REPORT SUMMARY

REFERENCE NUMBER: 23/503936/FULL		
APPLICATION PROPOSAL: Partial demolition and conversion of existing redundant stable building to a single dwellinghouse with associated parking, ecological enhancements, and landscaping (resubmission of 22/505429/FULL).		
ADDRESS: The Old Stable Dunn Street Road Bredhurst Gillingham Kent ME7 3LY		
RECOMMENDATION: REFUSE PLANNING PERMISSION		
SUMMARY OF REASONS FOR RECOMMENDATION: <ul style="list-style-type: none"> • Domestication of the building with insertion of fenestration and domestic paraphernalia would have an adverse impact on the design and appearance of the building and local character of this open rural landscape causing unacceptable harm to the character and appearance of the countryside and the Kent Downs National Landscape. • Development would neither maintain or enhance the distinctiveness of the countryside and Kent Downs National Landscape, contrary to policies SS1, SP17, DM1, DM30 and DM31 of the Maidstone Borough Local Plan (2017), the National Planning Policy Framework (2023) and the Kent Downs AONB Management Plan 2014 to 2019 (Second Revision) (2014) Policies SD1, SD2, SD7 and SD9. • Fails to demonstrate that a

Proposed Block Plan

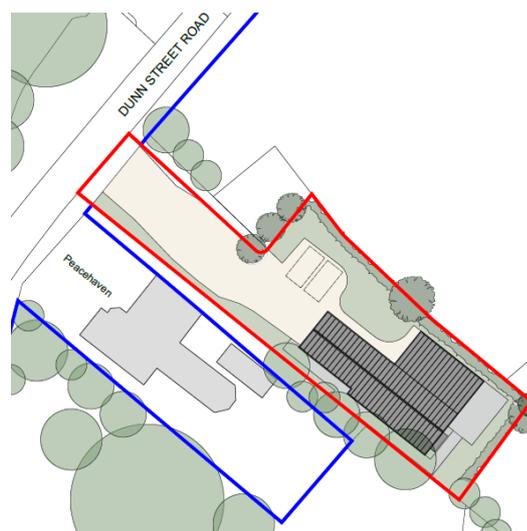
- 2.02 The existing area of hardstanding (circa 234m²) will be retained as the setting to the converted building, with an additional car parking area provided (45m²). The land to the side of the building provides an amenity area.

- 6.18 The submitted proposal includes the retention of the significant existing area of hardstanding that provides a poor building setting to Dunn Street Road. The proposal also includes loss of adjacent unmade ground with provision of car parking spaces additional to and adjacent to the existing hardstanding.

- 6.21 The site layout includes the retention of a large area of hardstanding that provides the building setting. A proposed additional area adjacent to the hardstanding provides two car parking spaces. The existing area of hardstanding has a negative visual appearance on the character and appearance of the area. The submitted application fails to provide any improvement to the existing situation with the harm increased by the additional parking area. The application fails to provide any justification for this large area of hardstanding and why existing hardstanding is not sufficient for car parking.
- 6.22 This layout has a suburban appearance and will be detrimental to the visual amenity of the countryside. The proposal fails to meet the requirements of DM31 1 iv).

Existing and proposed southwest elevations.

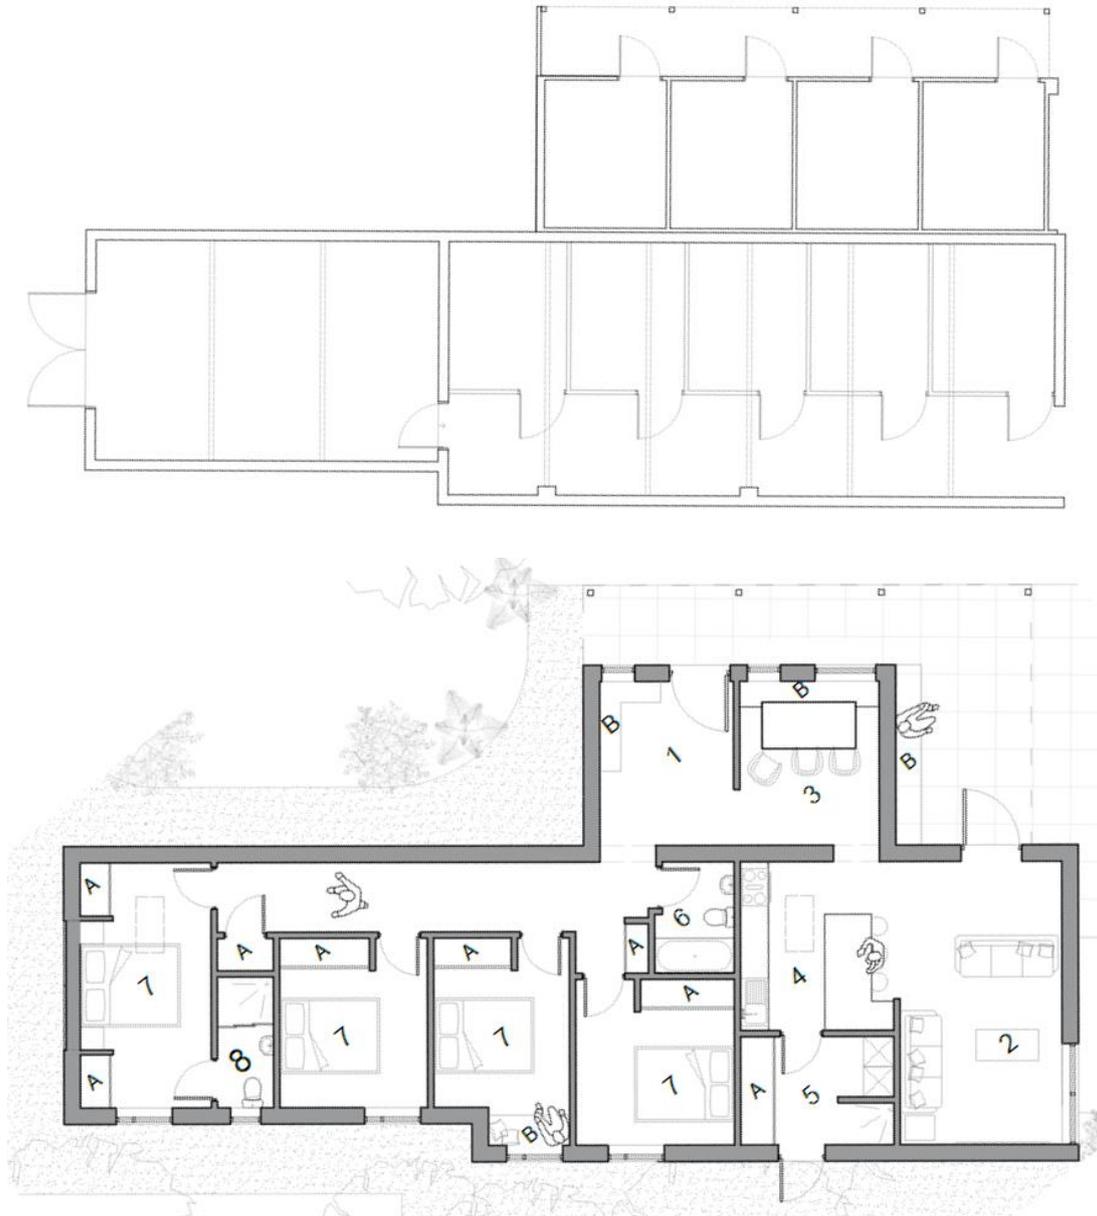
- 6.17 The proposed changes made as part of the conversion are not in keeping with the existing character of the site, including the number and style of new window and door openings (changes to the southwest elevation highlighted above).

- 6.19 The domestication of the building appearance with the new fenestration retention of hardstanding areas and new parking area would have an adverse impact on the design and appearance of the building and the site generally, and this impact together with the introduction of domestic paraphernalia into the open landscape would result in urbanising development in this rural landscape.
